EAST RENFREWSHIRE COUNCILLOCAL REVIEW BODY15 May 2019Report by Deputy Chief ExecutiveREVIEW OF CASE - REVIEW/2019/04SUB-DIVISION OF FEU AND ERECTION OF DWELLINGHOUSE (FRONTING
OTTERBURN DRIVE) AT 9 PERCY DRIVE, GIFFNOCK**PURPOSE OF REPORT**

2. Application type: Full Planning Permission (Ref No:- 2018/0764/TP).
- Applicant: Mr Daniel Modlin.
- Proposal: Sub-division of feu and erection of dwellinghouse (fronting Otterburn Drive).
- Location: 9 Percy Drive, Giffnock.
- Council Area/Ward: Giffnock and Thornliebank (Ward 3).

Proposed Site Plan

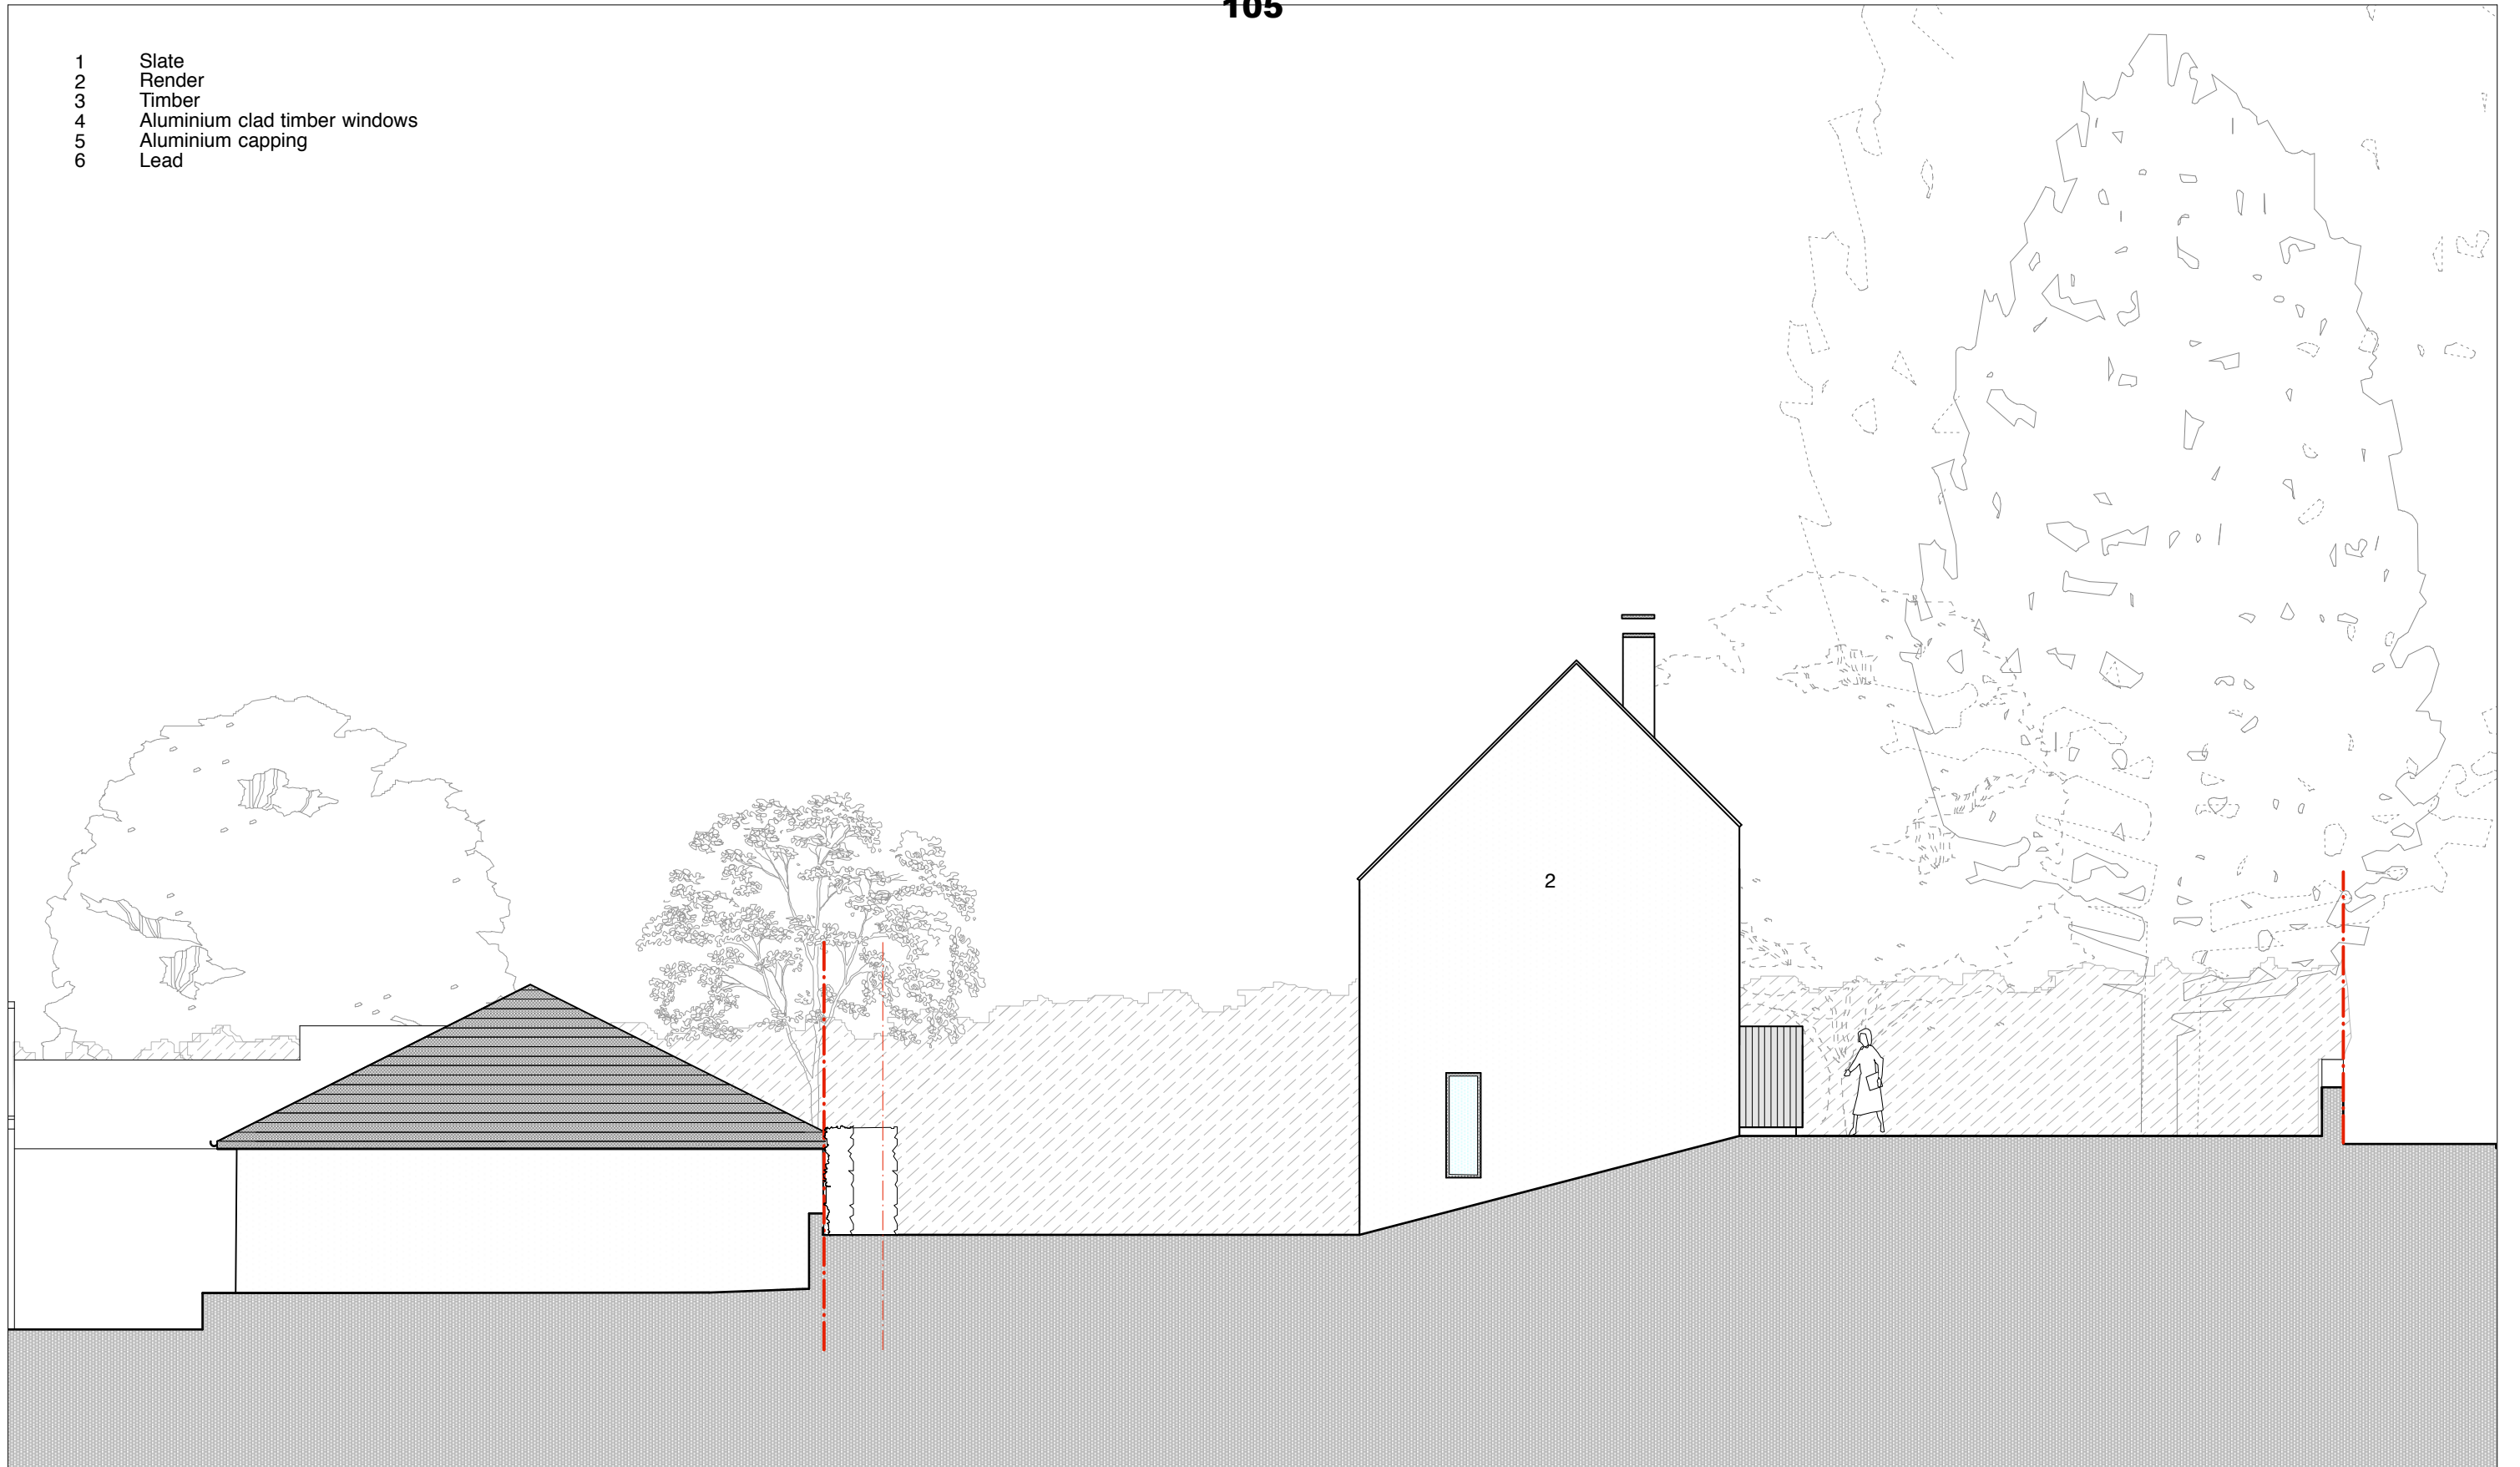
It is very clear from the site plan that the proposed development fails all the tests of size, scale, massing and density. The footprint of the house and the parking space takes up a significant and disproportionate part of the development site, in complete contrast to other nearby properties at Otterburn Drive. Further, the loss of garden ground to 9 Percy Drive would result in a similar disproportionality for that house.

The Application site plan suggests from the proximity of the buildings one to another that the construction of the house would involve a major loss of privacy to both 9 and 11 Percy Drive. What this plan does not show, but what is immediately obvious on a site inspection, is that there is an upwards slope from Percy Drive to Otterburn Drive, Otterburn Drive being at a level of perhaps three or more metres above Percy Drive, with the upwards angle of the slope being more pronounced for the last fifteen metres or so moving westwards. The site for the new house will therefore inevitably be at a *considerably higher level than both 9 and 11 Percy Drive and therefore overlook and dominate both.*

The plans make it obvious how very close the walls of the new structure are to be to the proposed development. In common with the previous Applications, the present Application plan shows the front westmost wall of the proposed new house approximately ten metres within the garden. The foundations and service pipes will cut through and destroy significant parts of the long established root systems of the protected trees. Those roots systems are part of the trees and therefore benefit from the same protections as the visible parts of the trees above the ground. The effect of such harm – on mature trees which will require their root systems for continued health - can only be their decline, death and then loss over a relatively short period of time.

The Application plans shows a new driveway coming out at Otterburn Drive precisely at the junction of Seyton Avenue which adjoins Otterburn at a right angle. A new house therefore inevitably anticipates increased traffic movement, and that directly opposite a right angled junction: it is therefore contended that the application is contrary to road safety considerations and should be opposed on those grounds.
